**World Forum for Harmonization of Vehicle Regulations****Working Party on Pollution and Energy****Sixtieth session**

**Regulation No. 83****(Emissions of M<sub>1</sub> and N<sub>1</sub> categories of vehicles)****Proposal for draft amendments to Regulation No. 83****Submitted by the expert from the International Organization of Motor Vehicle Manufacturers \***

The text reproduced below was prepared by the expert from International Organization of Motor Vehicle Manufacturers (OICA) in order to amend the requirements of Regulation No. 83, to update the specifications for the proportional speed fan which can be used during testing of the vehicle on the chassis dynamometer. This document is based on informal document No. GRPE-59-06 distributed at the fifty-ninth session of the Working Party on Pollution and Energy (GRPE) (see report ECE/TRANS/WP.29/GRPE/59, para. 30). Modifications to the current provisions of the Regulation are marked in bold characters for new and as strikethrough for deleted text.

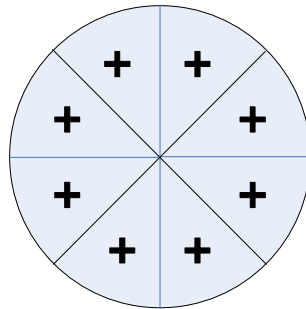
(b) For circular blower outlets, the outlet shall be divided into 8 equal arcs by vertical, horizontal and  $45^\circ$  lines. The measurement points lie on the radial centre line of each arc ( $22.5^\circ$ ) at a radius of two thirds of the total (as shown in the diagram below).

**These measurements shall be made with no vehicle or other obstruction in front of the fan.** Each value at those points shall be within 10 per cent of the averaged value of themselves.

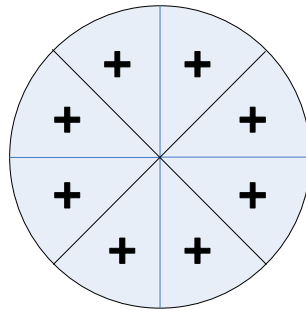
(b) For circular blower outlets, the outlet shall be divided into 8 equal arcs by vertical, horizontal and  $45^\circ$  lines. The measurement points lie on the radial centre line of each arc ( $22.5^\circ$ ) at a radius of two thirds of the total (as shown in the diagram below).

**These measurements shall be made with no vehicle or other obstruction in front of the fan. Each value at those points shall be within 10 per cent of the averaged value of themselves.**

Figure 1

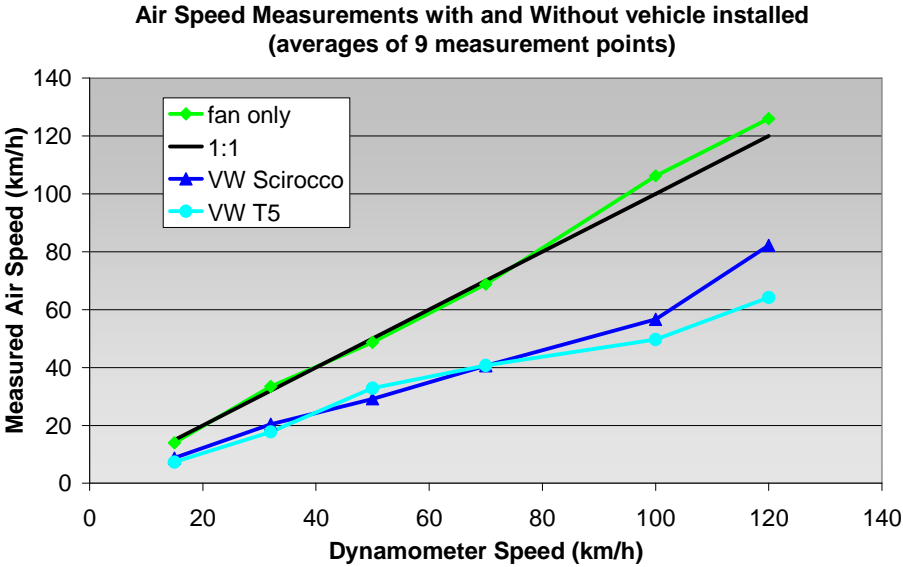
6. Should the measurements be made with or without a vehicle? The requirement is purely a specification of the fan suggesting that the “no car” measurements are correct, but the test is of course performed with a vehicle in place suggesting that the “car” measurements are correct. A comparison of “car” and “no car” measurements (see figure 1) reveals however that due to the flow restriction caused by the vehicle, no meaningful measurements can be made with a vehicle installed.

9. The data in figure 2 shows clearly that the central zone shows a greater deviation from the average than all of the outer zones. There is no requirement to make a central measurement for circular fans as this deviation would be expected along the axis of a propeller. However, many rectangular fans are merely rectangular outlets from a circular propeller and, therefore, requiring this central measurement from fans with rectangular outlets is also unreasonable.

7. OICA therefore proposes to add the statement that air flow measurements must be made with no vehicle installed in front of the fan.
8. This still leaves the issue of the requirement for all measurement to be within  $\pm 10$  per cent of their average.

11. OICA therefore proposes to delete the  $\pm 10$  per cent requirement.
